CCK-2979.00-1-26

UK North Farm Seedhouse

ADDENDUM #4

UK Project #: 2979.0 Seedhouse

N
A110

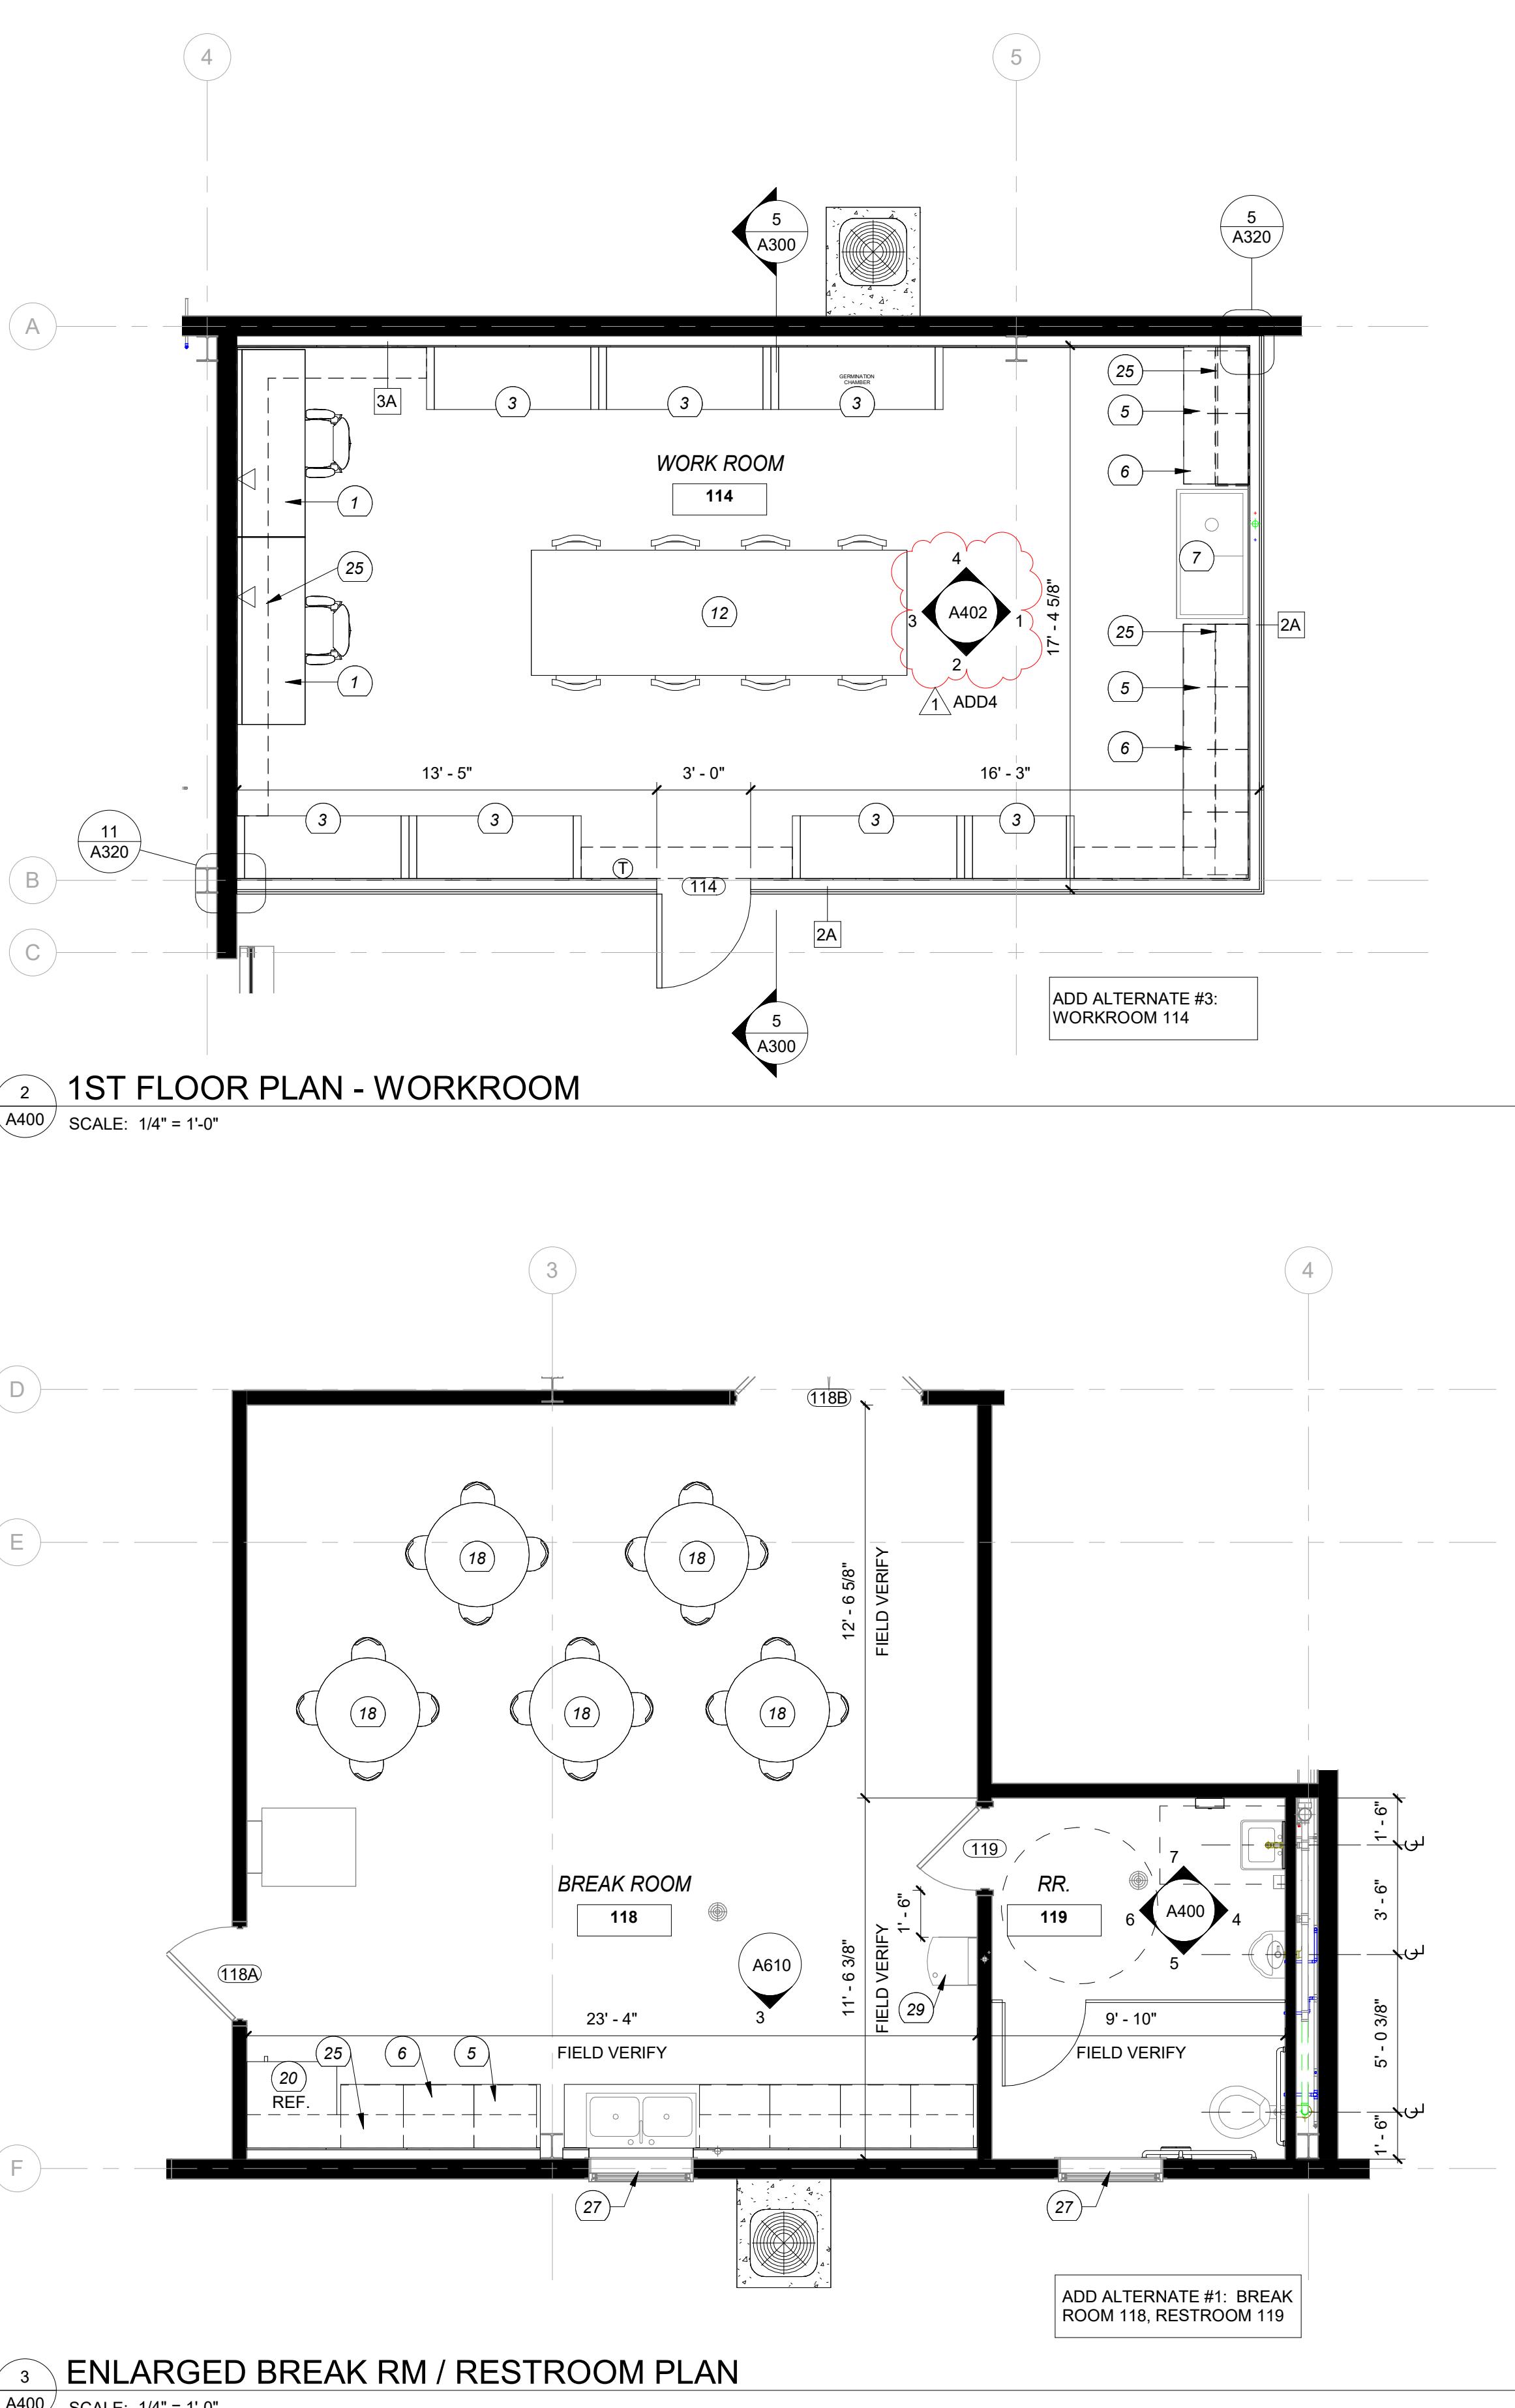
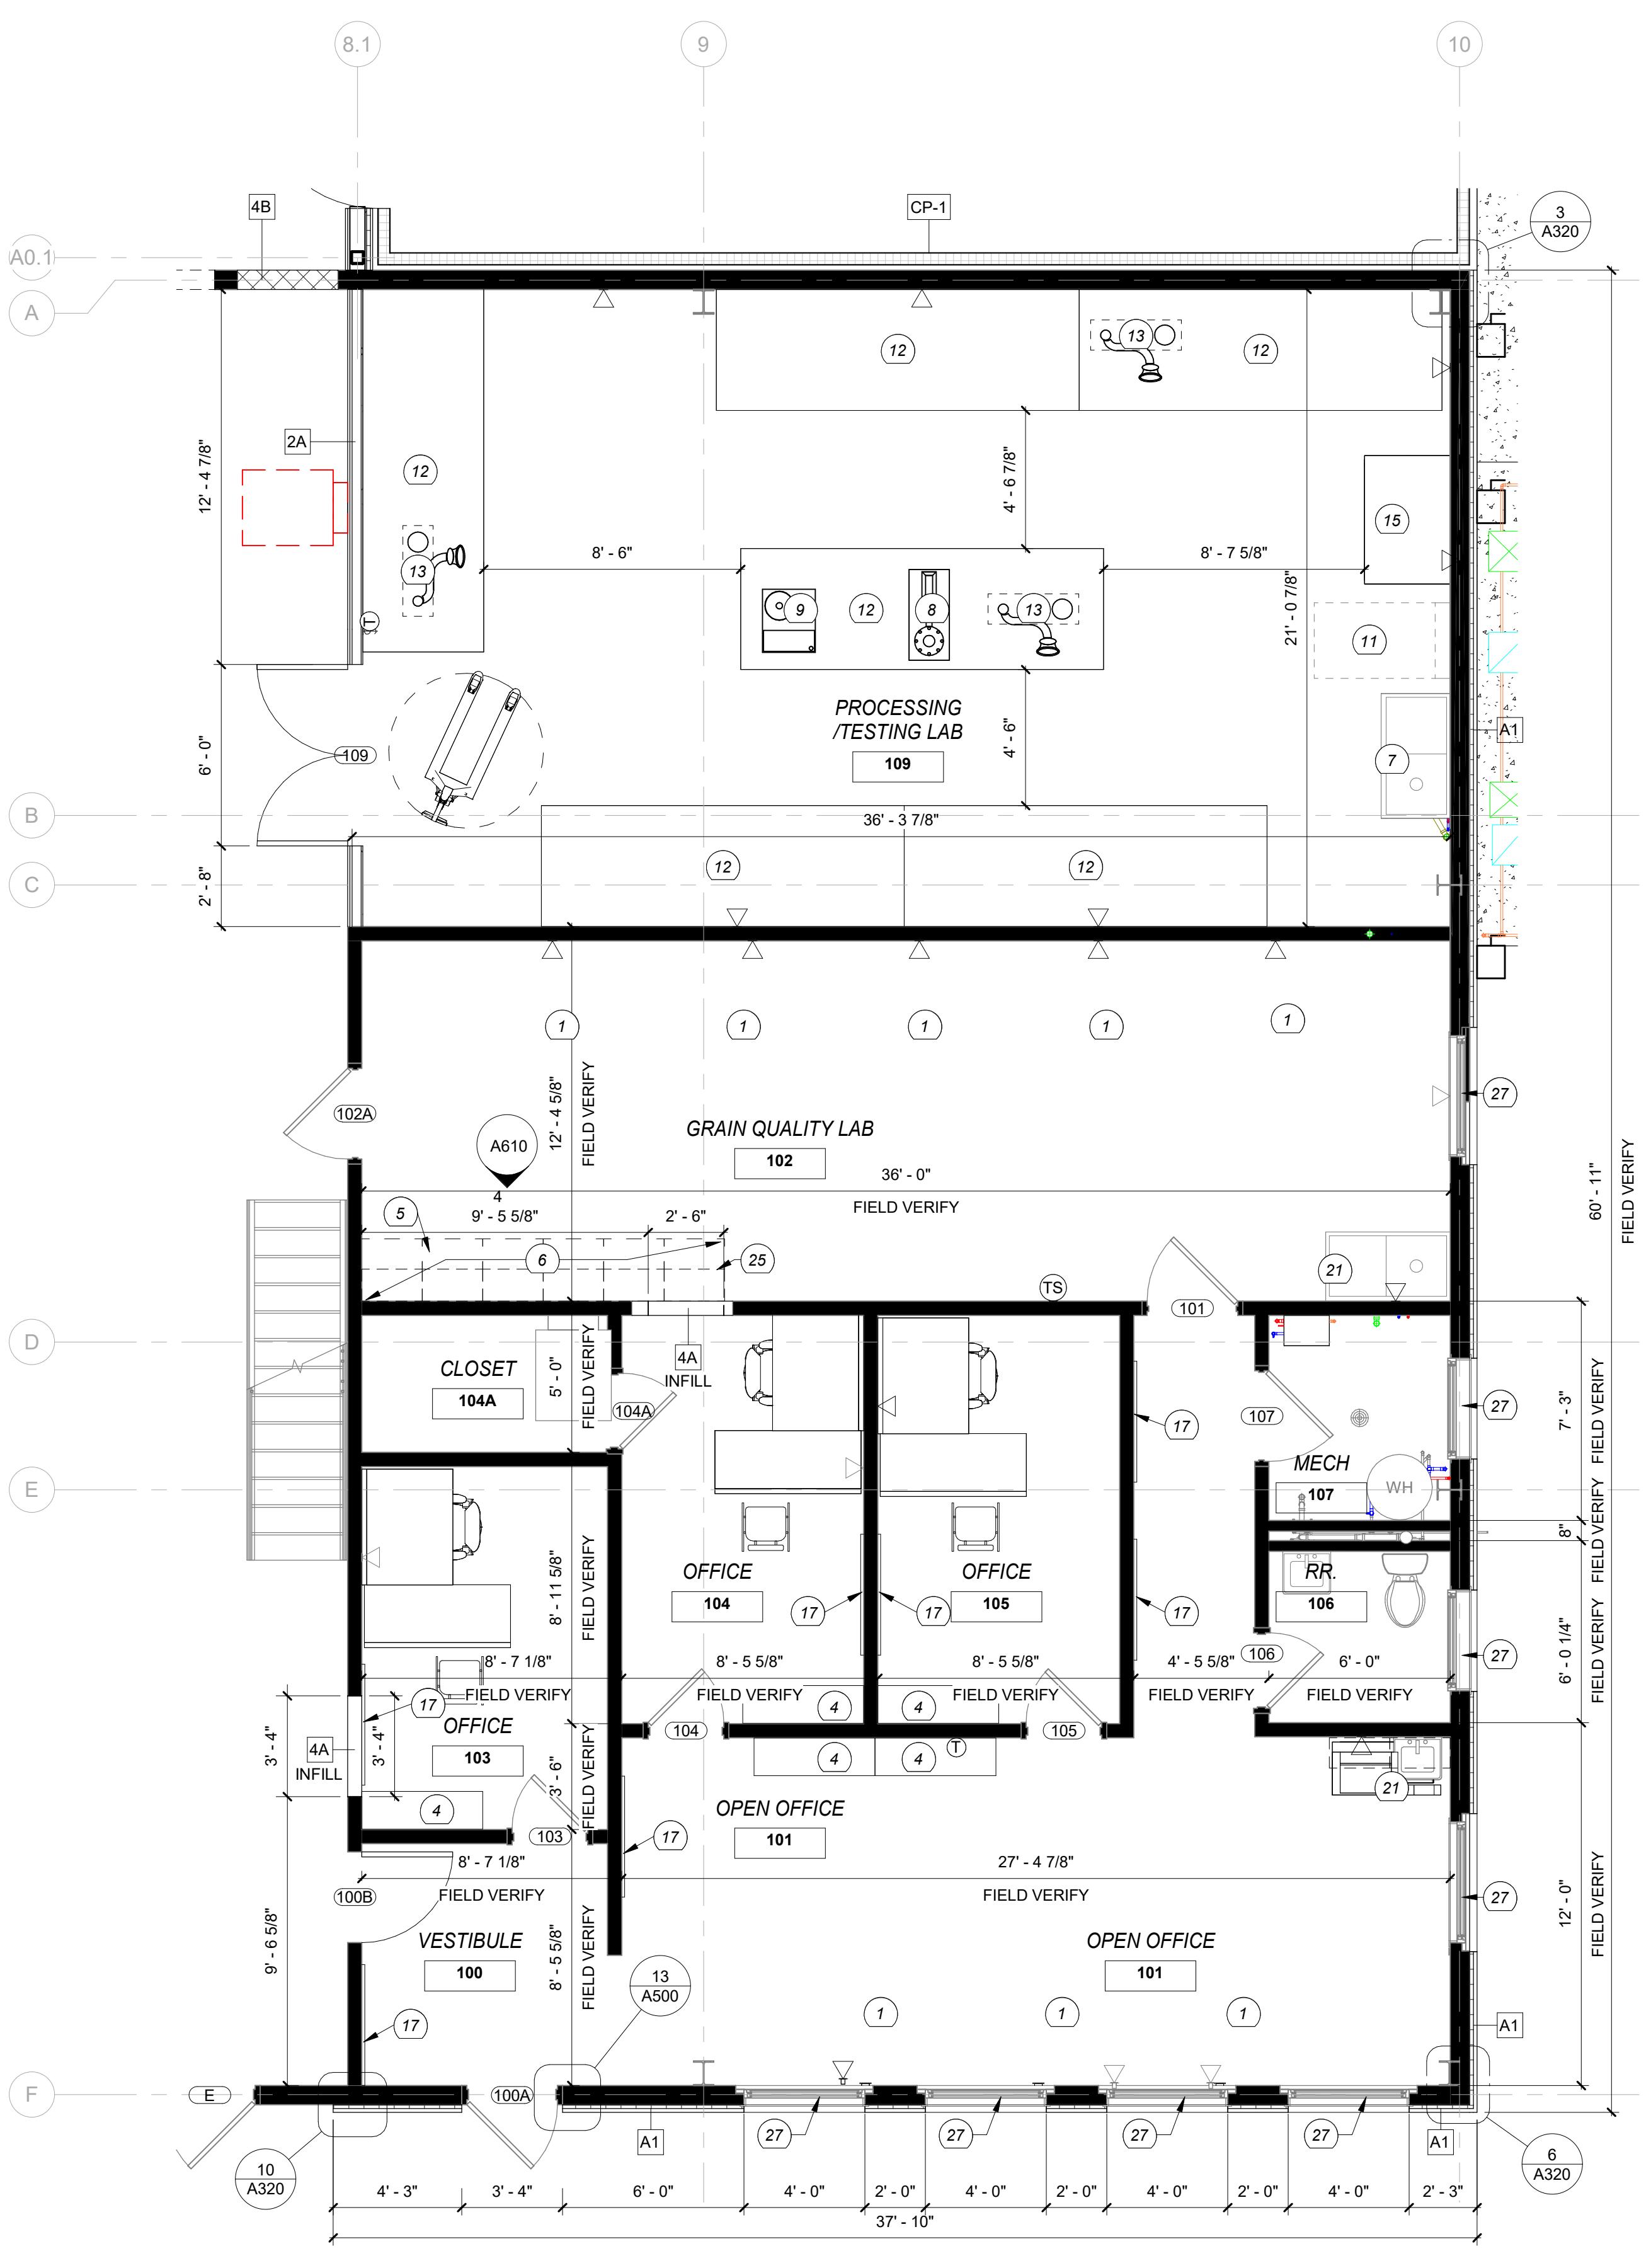
2. Refer to attached revised sheet G002 – CODE SHEET for updated code information.
3. Refer to attached revised sheet A110 – FIRST FLOOR for updates to FLOOR PLAN CODED NOTES:

- a. Code Notes 3, 4, 12, 14, and 20 are to be changed to 'OFOI'.
4. Refer to attached revised sheet A400 – ENLARGED FLOOR PLANS for added Interior Elevation markers at Work Room 114.
